# Work Order ID 96982

Item Name: Crosstube Turning Detail

<b>DART AEROSPACE LTD</b>	<b>Work Order:</b>	96982
<b>Description:</b> Crosstube Assembly	<b>Part Number:</b>	D407-667-145
<b>Inspection Dwg:</b> D407-667-145 Rev: C		Page 1 of 2

DRAWING NO. D407-667-145	TITLE CROSSTUBE ASS'Y (407 HIGH FWD)	REV. C	<b>DART AEROSPACE LTD ENGINEERING ORDER</b>		D.E.O. NO. D407-667-145-C-1	SHEET NO. SHEET 1 OF 1	SCALE NTS
DRAWN <i>q</i>	CHECKED <i>ASS</i>	MFG. APPR. <i>IB</i>	APPROVED <i>WD</i>		DE APPR. <i>##</i>		
DATE 11.07.15	DATE 11.07.22	DATE 11.07.22	DATE 11/07/22		DATE 11.07.21

**DETAIL P**  
BONDING STRAP INSTALLATION 2 PL

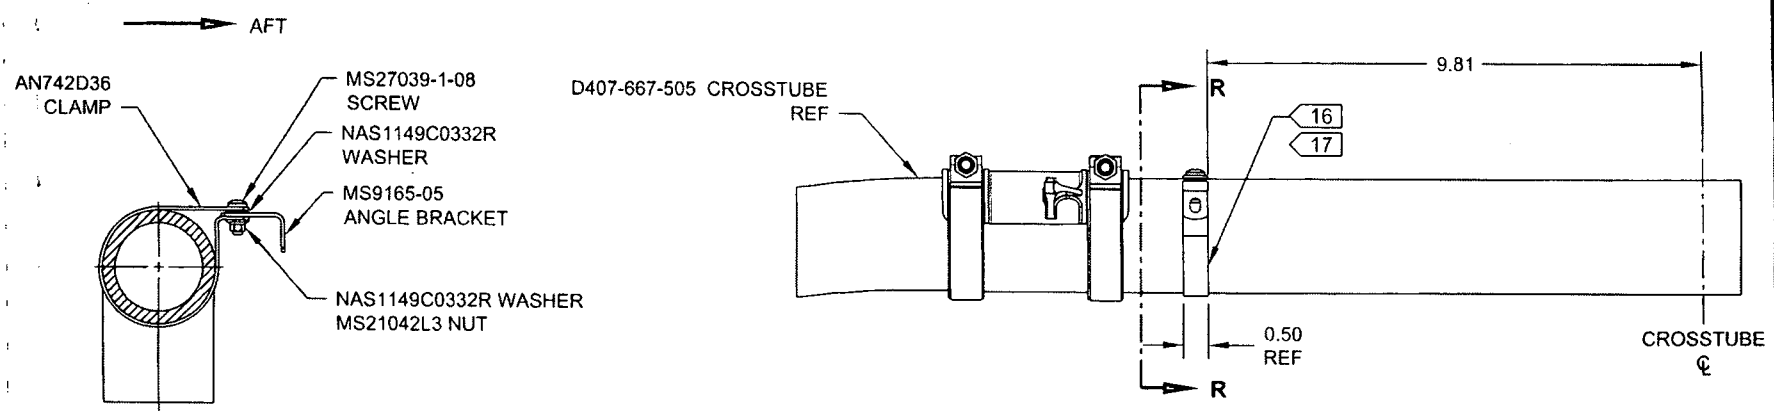
ADD ELECTRICAL GROUNDING STRAP

ITEM	QTY -145	PART NUMBER	DESCRIPTION
1	X	D407-667-145	CROSSTUBE ASSEMBLY (407 HIGH FWD)
⚡			
10	2	AN742D36	CLAMP
11	2	MS9165-05	ANGLE BRACKET
12	2	MS21042L3	NUT (OR MS21042-3)
13	2	MS27039-1-08	SCREW
14	4	NAS1149C0332R	WASHER (OR AN960C10L)

- 16) MASK AREA UNDER CLAMP PRIOR TO PAINTING
- 17) SEAL EDGES WHERE AN742D36 CLAMP MEETS WITH THE CROSSTUBE USING SIKAFLEX-241/-291 OR MIL-S-8802 CLASS B2 OR PROSEAL 890 SEALANT
- 18) PERFORM RESISTANCE CHECK TO ENSURE MAX RESISTANCE IS 10 MILLIOHMS
